**ADDENDUM NO. 1**

**MLK ELEMENTARY SCHOOL  
TRANSITIONAL KINDERGARTEN  
BAKERSFIELD CITY SCHOOL DISTRICT**

**Project No.: 5593  
DSA File No. 15-6  
DSA App No. 03-123900  
December 20, 2024**

Sheet No.:  
**E1.03**

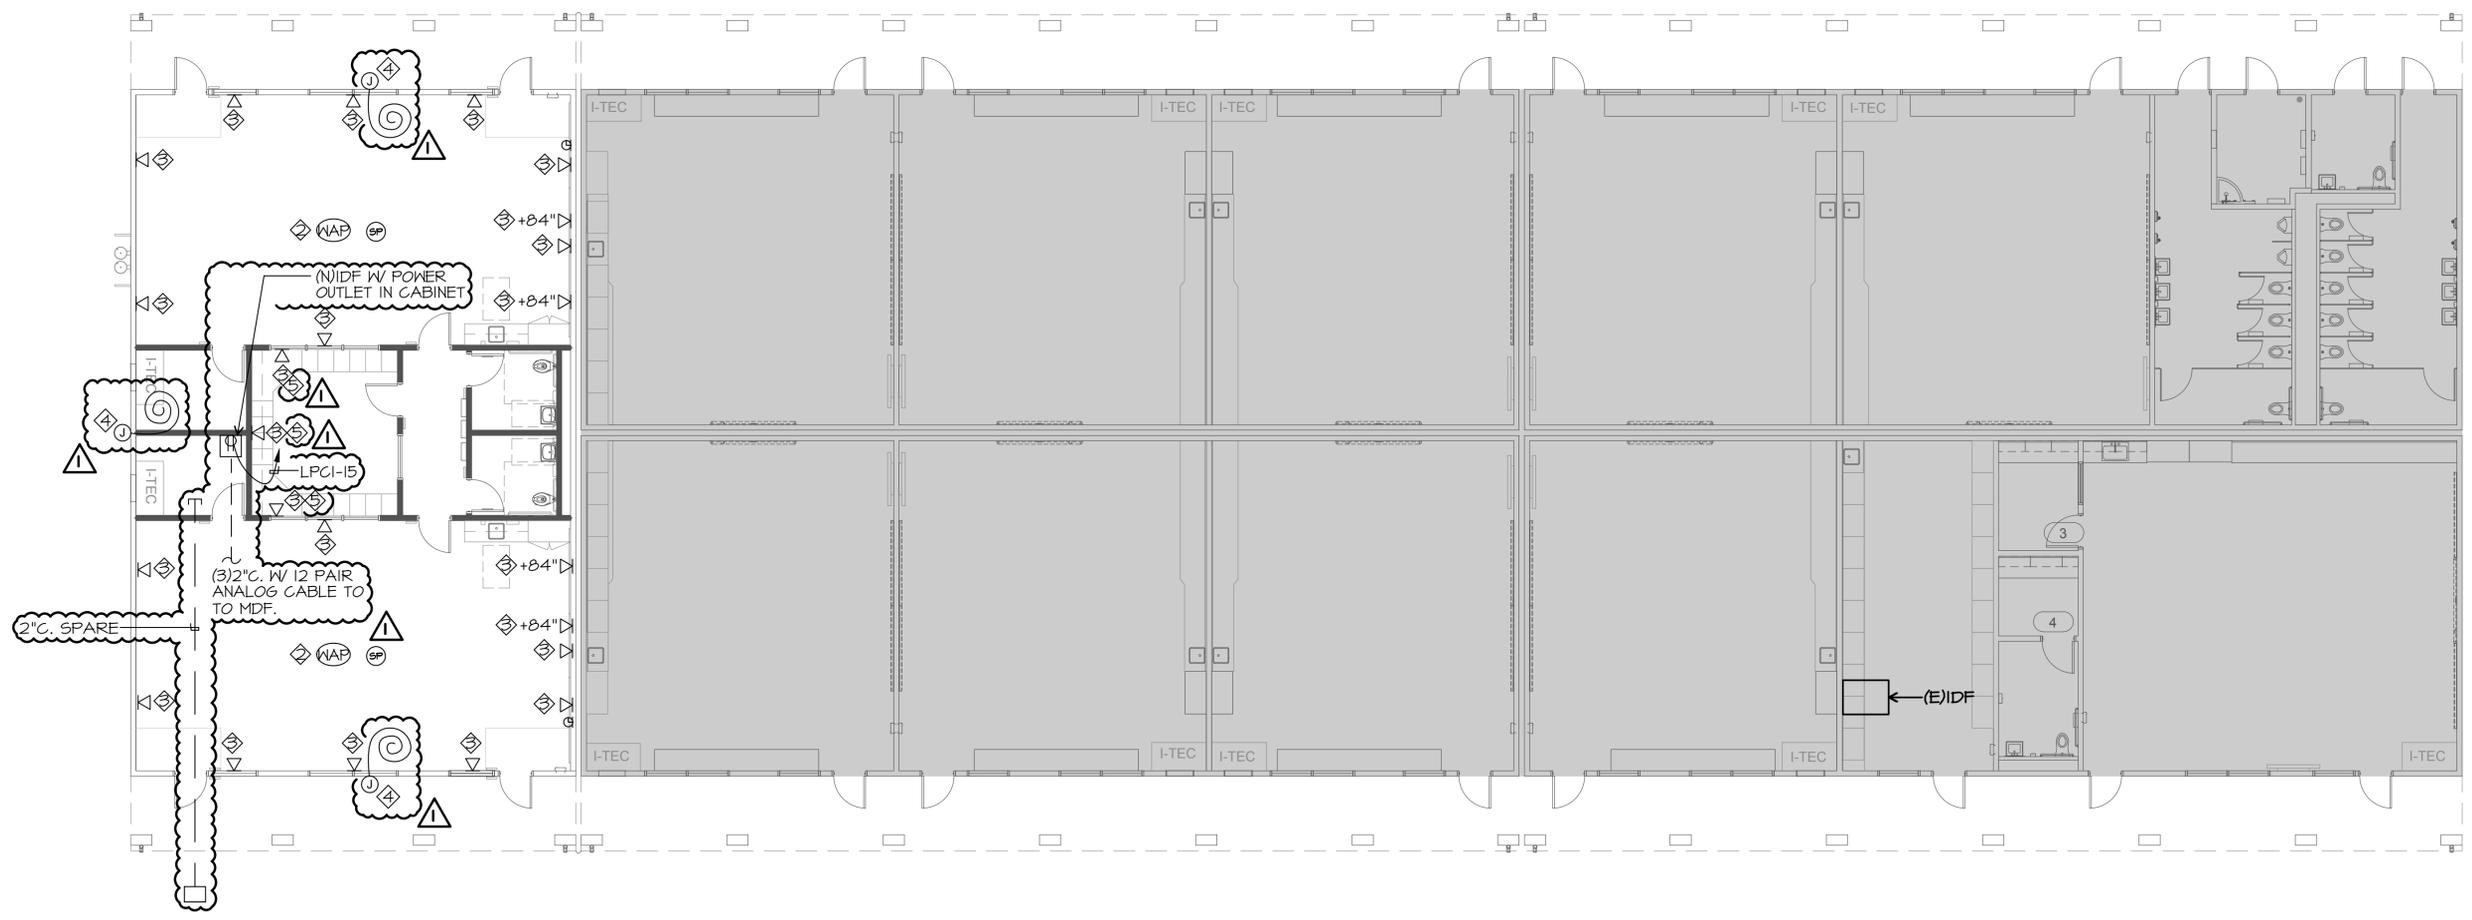
**1-13 DRAWING, SHEET E-1.03 – DATA AND COMM PLAN:** Note the following changes (See E1.03 addendum 1 drawing):

1. Add spare conduit and pull box
